SIGN DETAILS

KAHUAPAANI ST. RESURFACING
Ulune St. to Salt Lake Blvd.

Fed. Aid Project No. STP-7241(1)
Scale: As noted Date: June, 1995

ADD. 36

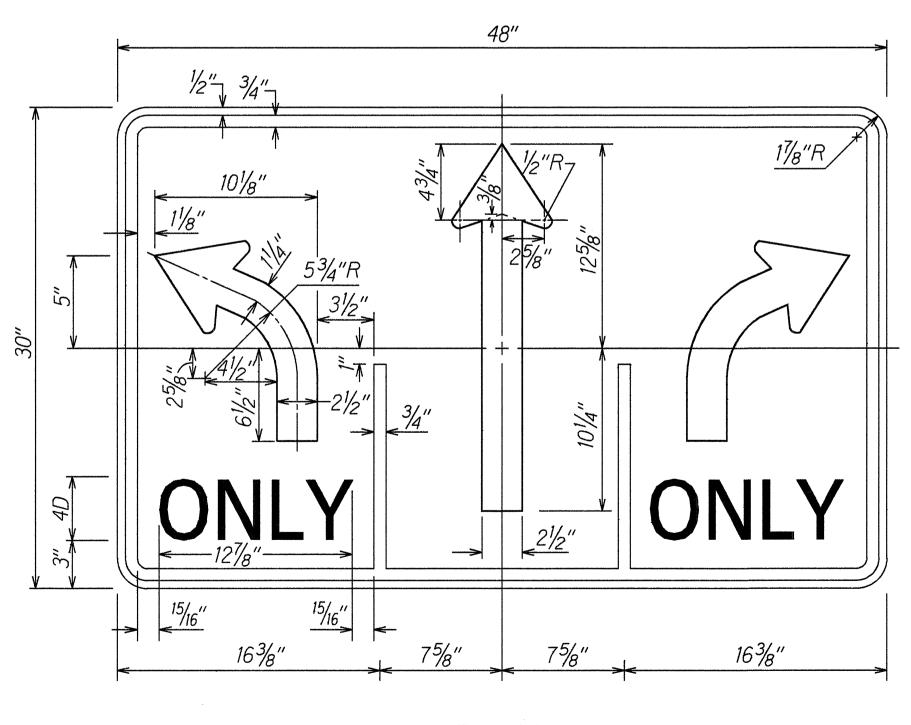
6/16/95 | Add Sign R3-55(L)
